# Technical Note to Inspector

## ABP-321519-25

<b>Development</b>	Construction of dwelling house, installation of wastewater treatment system, and for all associated site works
<b>Location</b>	Dromsullivan South, Bantry, Co. Cork
<b>Planning Authority</b>	Cork County Council
<b>Planning Authority Reg. Ref.</b>	24500
<b>Applicant(s)</b>	Shauna O'Sullivan
<b>Appellant(s)</b>	Eugene O'Sullivan
<b>Type of Application</b>	Normal Planning Appeal
<b>Inspector</b>	Aisling Mac Namara
<b>Scientist</b>	Finbarr Quigley

Figure 2.3 Groundwater flow and location of features on the site

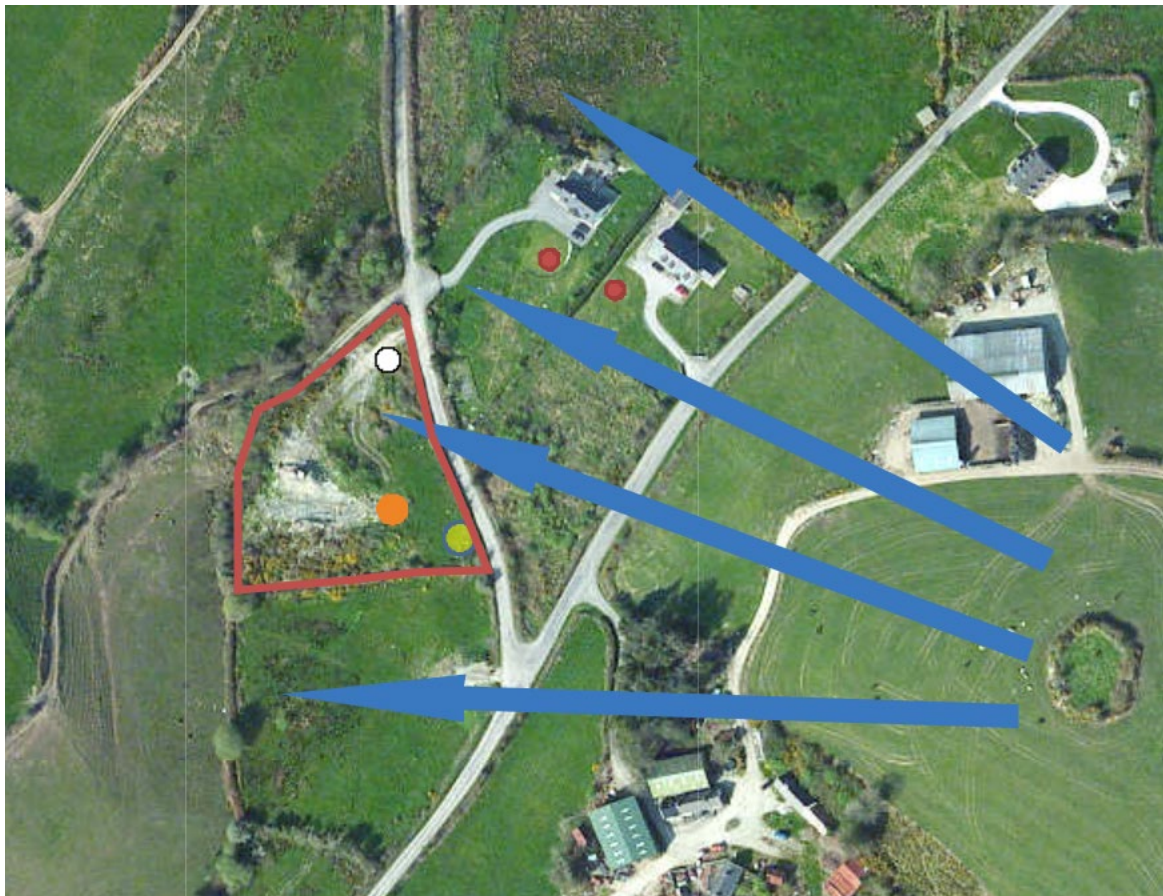
The location of the proposed drinking water well and its location relative to neighbouring wastewater treatment system was raised. Figure 2.3 shows the approx. location of the proposed well (in white) relative to the neighbouring wastewater treatment systems (in red) and the blue arrows indicate the groundwater flow direction. The groundwater is considered to be flowing from the elevated position to the ESE of the site towards the surface watercourse which runs along the NW and W boundary of the site.

- 2.3.2. Given the groundwater flow direction, the wastewater from the neighbouring dwellings could be considered to be up-gradient from the proposed well at distances of 55m and 70m. The CoP specifies distances which new wastewater treatment systems should be located from existing wells and is not designed to be used as a guide to locating a new well. The EPA Safesystem Guidance on private well

protection and maintenance recommends that homeowners ensure that a wastewater system including septic tanks are not located within 30m of a well. The Institute of Geologists of Ireland have produced a guidance document ([link](#)) on Water Well Construction which identified that the minimum recommended distance (m) of a private well from likely pollution sources (incl. septic tank percolation area) was between 30 and 60m depending on the type and depth of subsoil present above bedrock. The proposed separation distances of 55m and 70m are considered to be sufficient to ensure the protection of drinking water supplies given the high groundwater vulnerability present at the two septic tanks near this site which indicates soil depths between 3-5m.

**Figure 2.5 Cork County Development Plan 2022-2028 Flood Zone A Map for the area surrounding the proposed development**

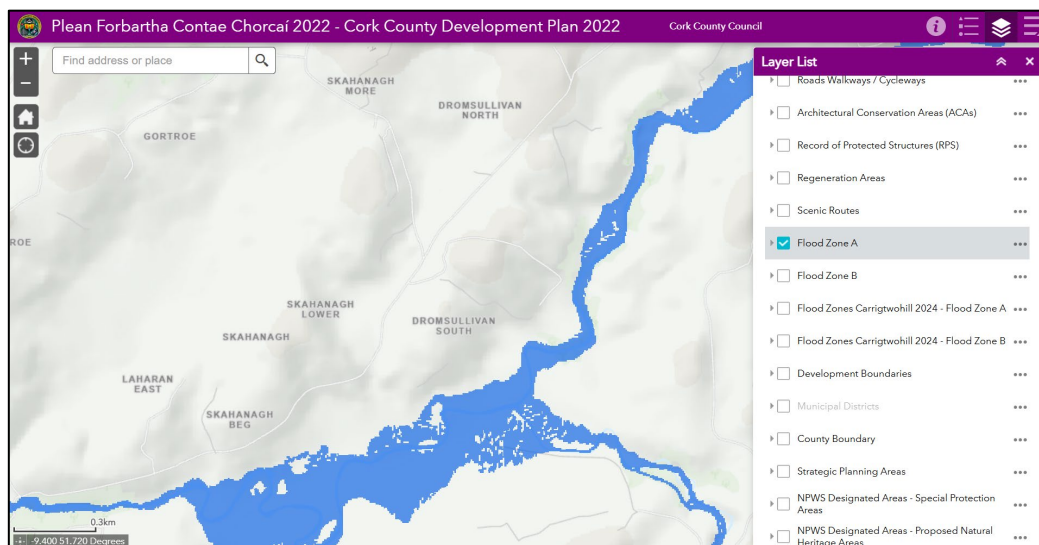
- 2.5.2. The Area Engineer from the PA searched the PA Catchment Flood Relief Assessment and Management drawings and concluded that the site in question was located in Flood Zone C which covers areas considered to have a low probability of flooding from fluvial or tidal sources. The Engineers report suggested that the watercourse next to the site was not identified as a flood risk on the internal PA mapping and the nearest identified risk area was located 200m downstream of the site in question.
- 2.5.3. The Flood Zone Maps included in the Cork County Development Plan 2022-2028 were assessed and the site was found to be outside Flood Zones A and B.

Figure 2.7 OPW 1 in 100 (Medium Probability) Flood Map for the area surrounding the proposed development

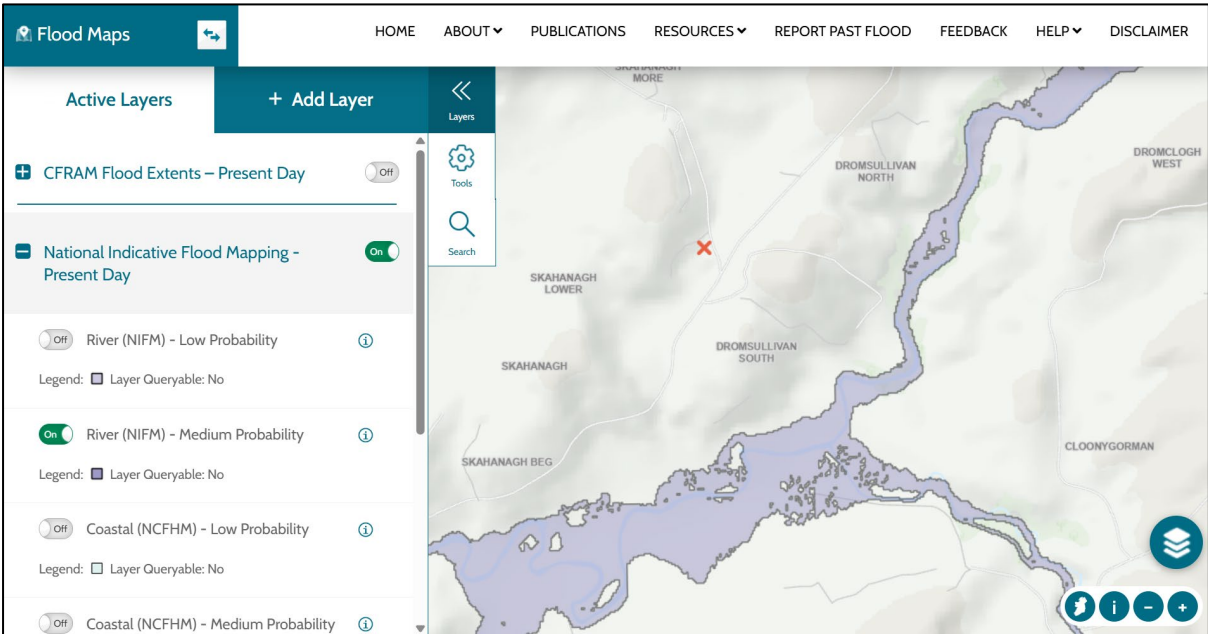
2.5.4. The OPW Flood Maps website ([www.floodinfo.ie](http://www.floodinfo.ie)) was searched for evidence of historic flooding records for the location in question. Despite there being records of flood events for other locations (not nearby) since the early 1980's present on the website, none were found that related to the site in question. The OPW National Indicative Flood Maps (see figures 2.7 and 2.8) were assessed and the location was not within the Low or Medium Probability areas identified adjoining the river Mealagh to the south of the site.

The proposed development site in question is elevated approx. 20m above the areas identified as being at Moderate risk of flooding. This suggests that areas at significantly lower elevation will flood before the site in question becomes at risk of flooding events.
